**City of Ramsey**  
**Agenda**  
**Environmental Policy Board (EPB)**  
**Monday, October 20, 2025**  
**6:30 pm**  
**Council Chambers, 7550 Sunwood Drive NW**

Consider Natural Resources Aspects of a Site Plan for CorTrust Bank (Project No. 25-123); Case of CorTrust Bank

**CORTRUST BANK**  
RAMSEY, MINNESOTA

**EXISTING CONDITIONS**  
**C1.1**

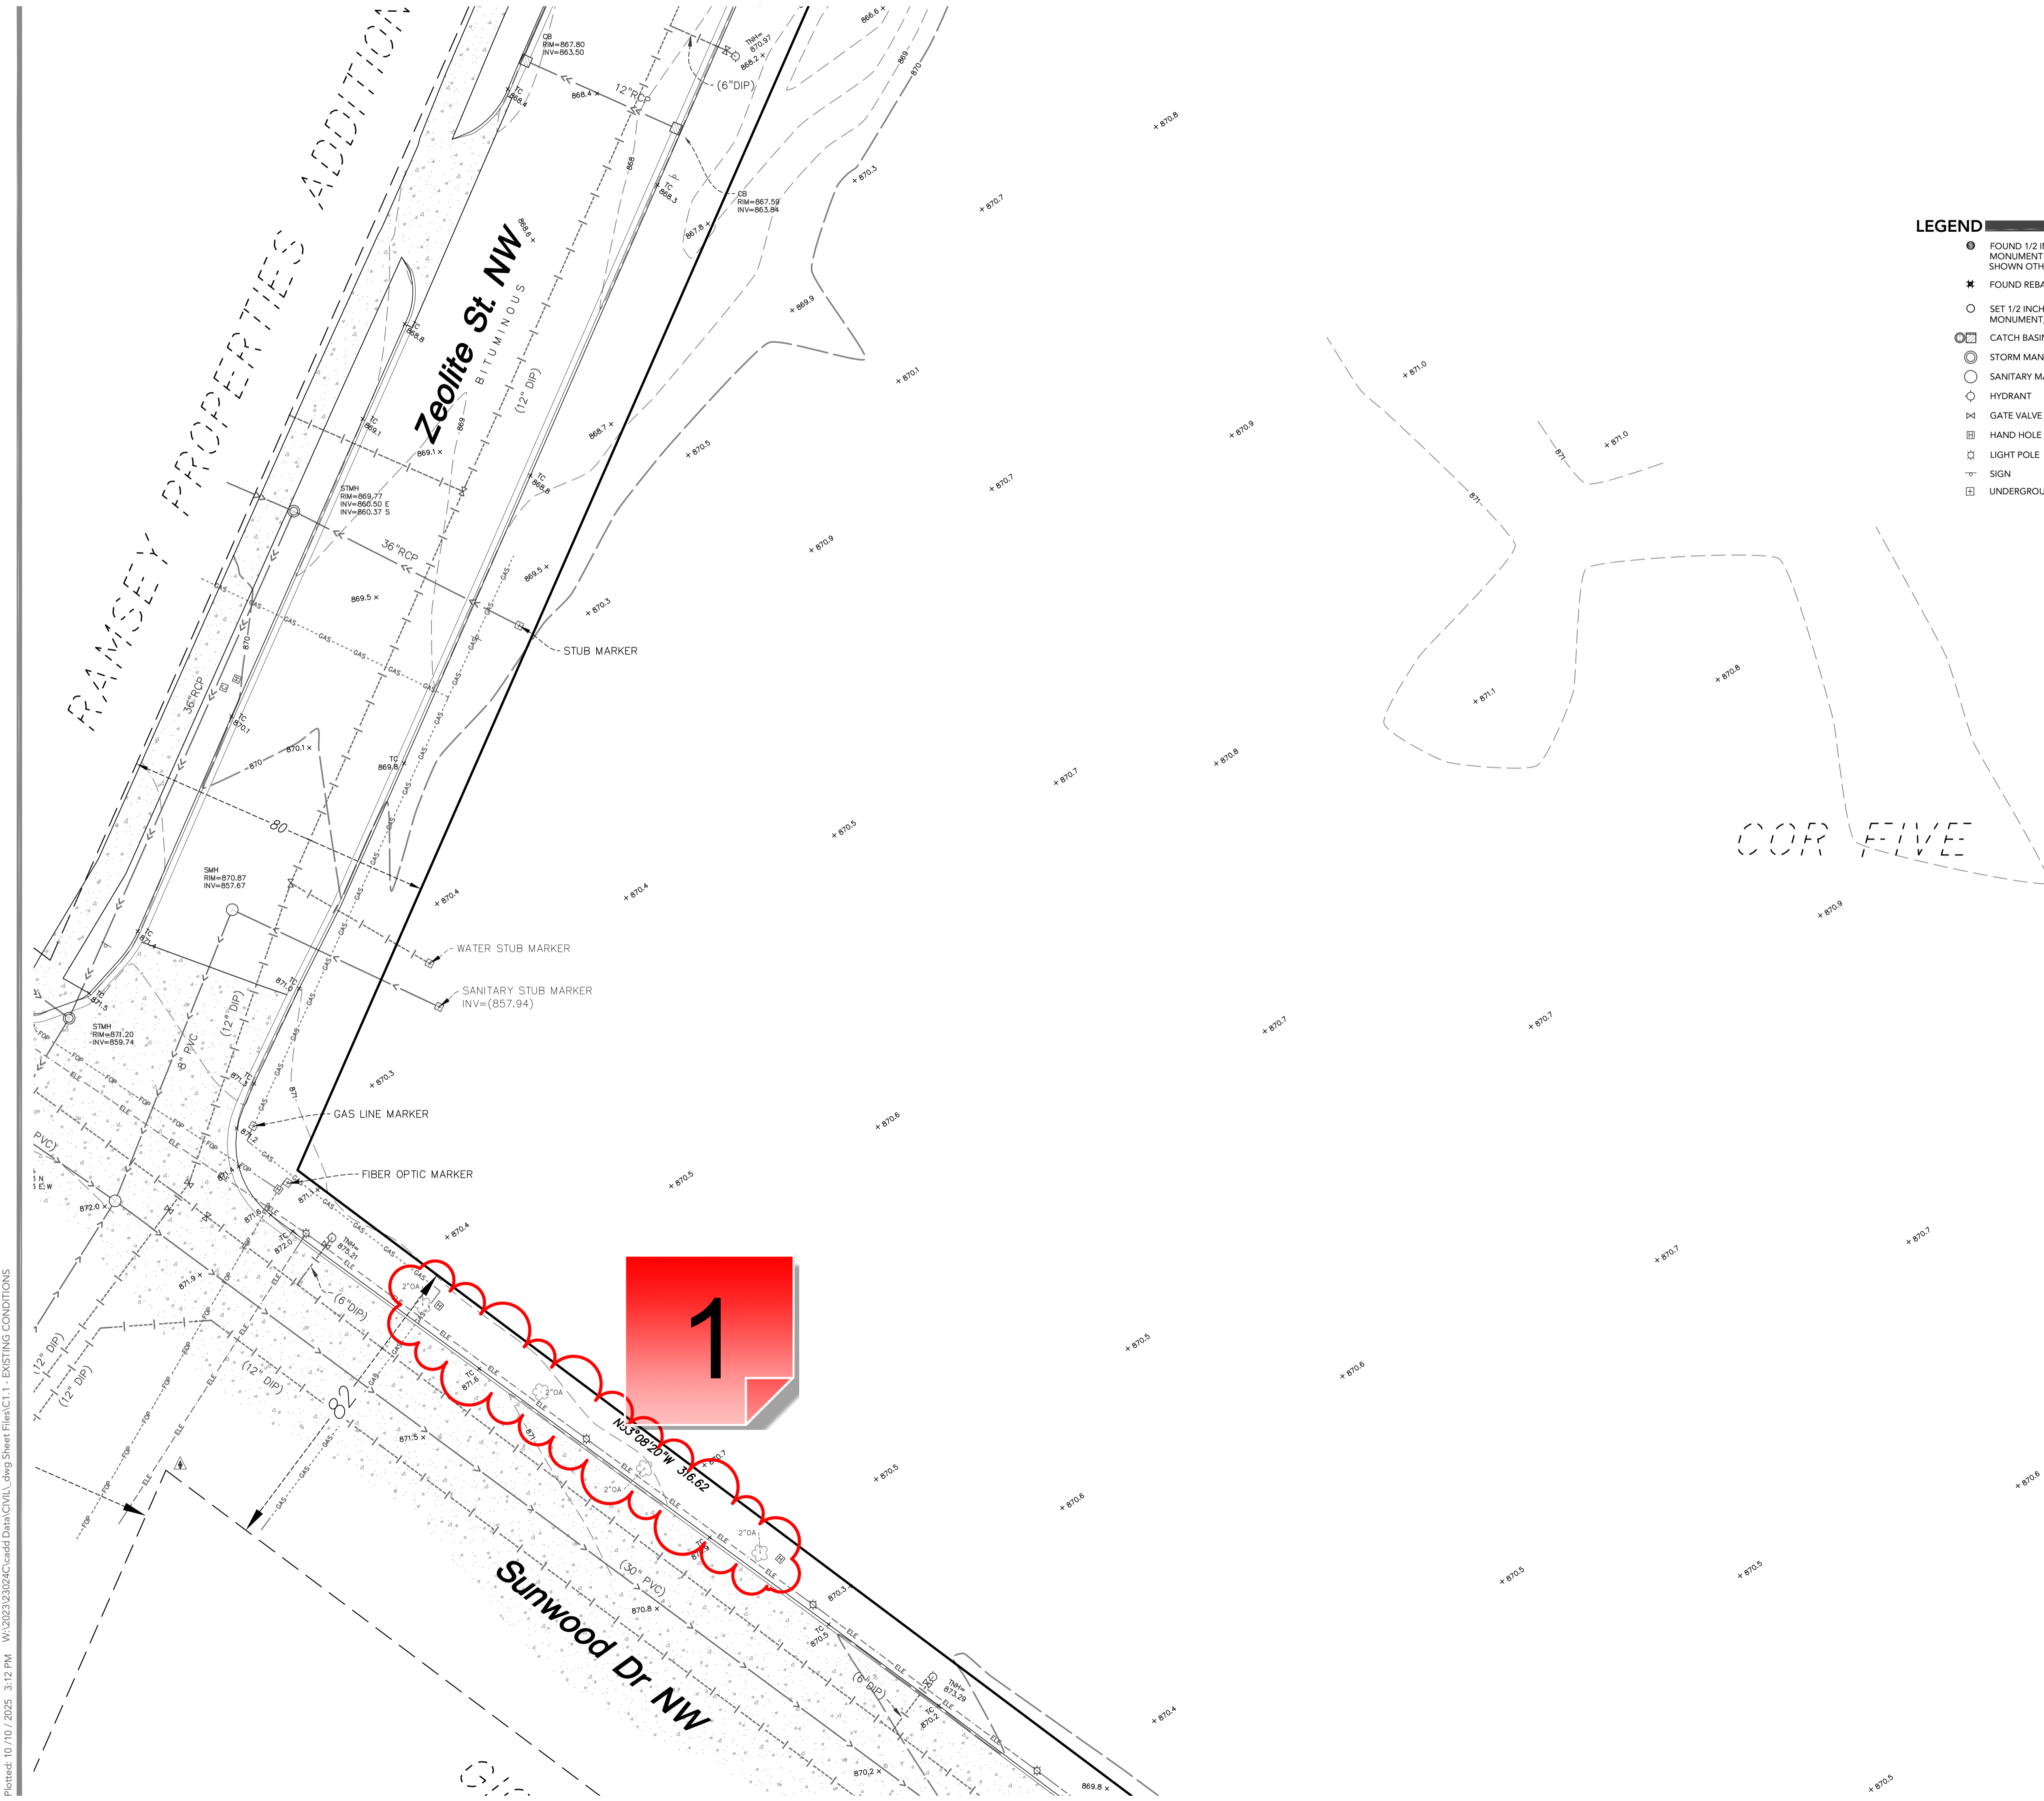
**1 - Salvage Existing Trees**

The City would like to salvage the existing boulevard trees, at least 3 of the 4 of them (the western most one was damaged by a vehicle, but the other 3 are healthy). Do not remove these trees. Please coordinate with the city to ensure that we can get these trees relocated.
